# CPU BOARD

149H179

(PCB 052H402A)

## MODIFICATION

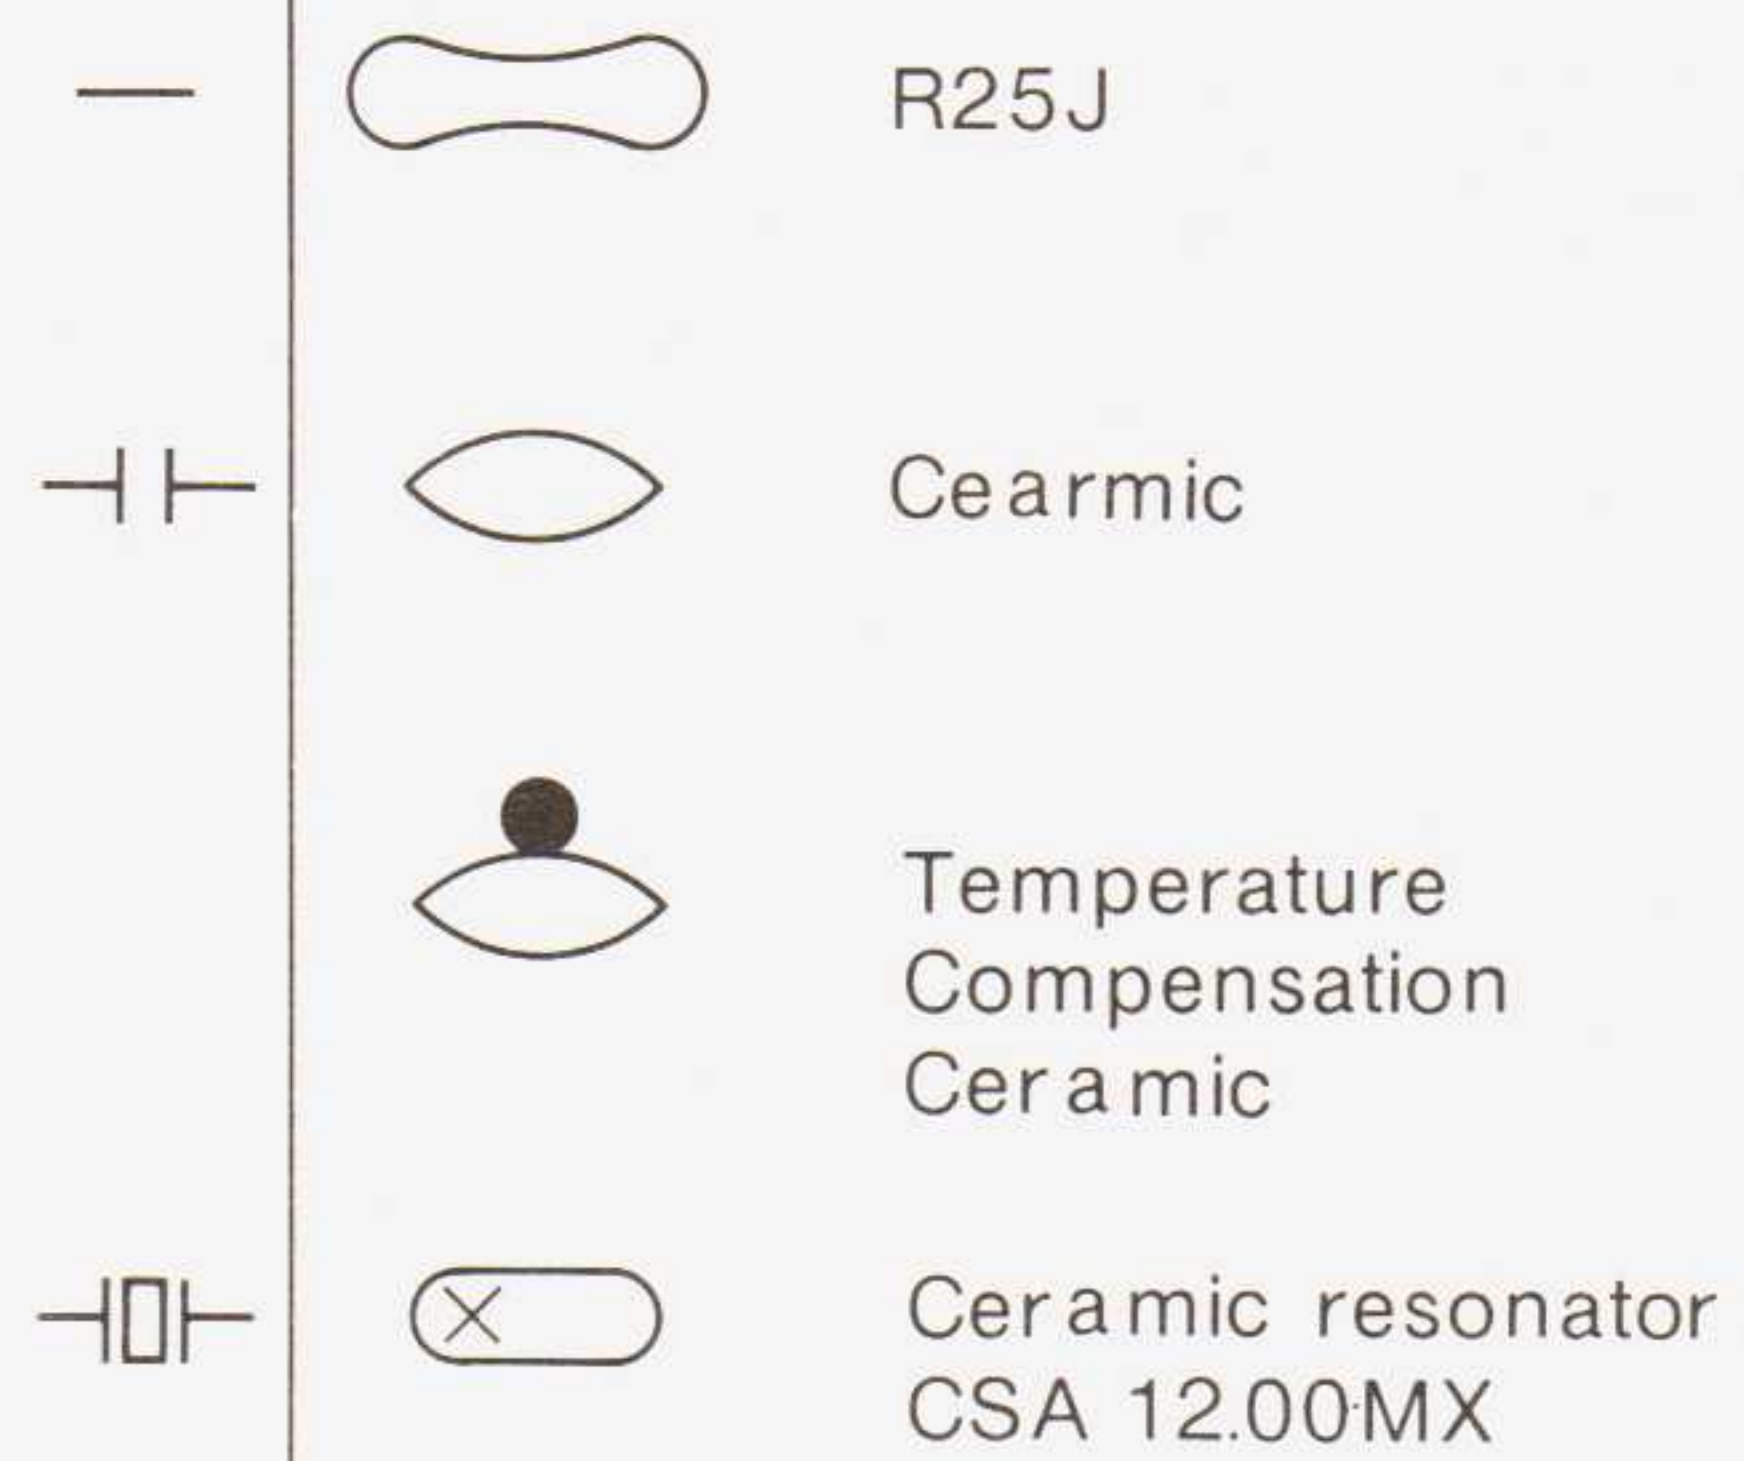
For positive switch scanning in TAPE modes.

See detailed information in PANEL BOARD R

Resistor  $33\Omega$

**View from foil side**

This modification is unnecessary when TR3, R24, R25 and R26 are present on PANEL BOARD R.
